Product Change Notification / SYST-24NJAY884

ERRATA - AVR32DB28/32/48 Silicon Errata and Data Sheet Clarifications Errata Document Revision

AVR32DB28/32/48

Silicon Errata and Data Sheet Clarifications

Figure 34-1. DAC Block Diagram

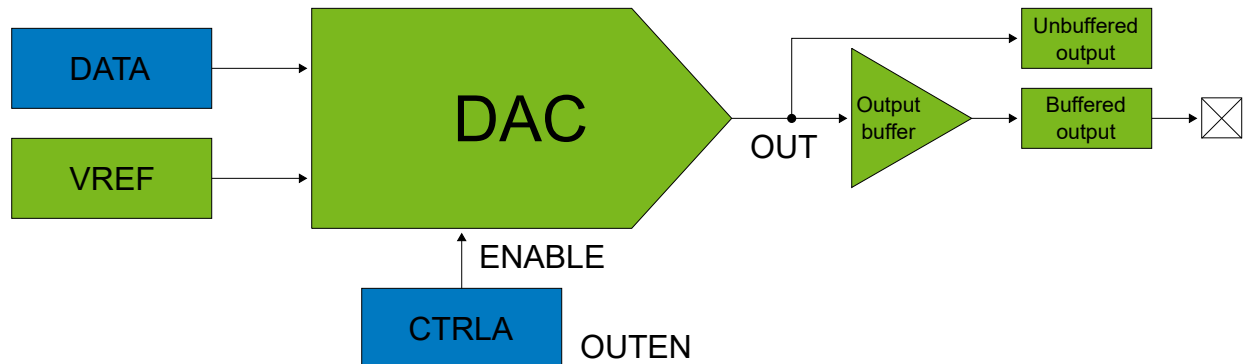
Clarifications of the block diagram and the DAC Output sub-section of the DAC peripheral has been made:

1. The block diagram is updated with clarifications to the output signal routing (buffered/unbuffered) and will replace the original block diagram.
2. Sections 34.3.2.3 (DAC as Source For Internal Peripherals) and 34.3.2.4 (DAC Output on Pin) are replaced by section 34.3.2.3 DAC Output.
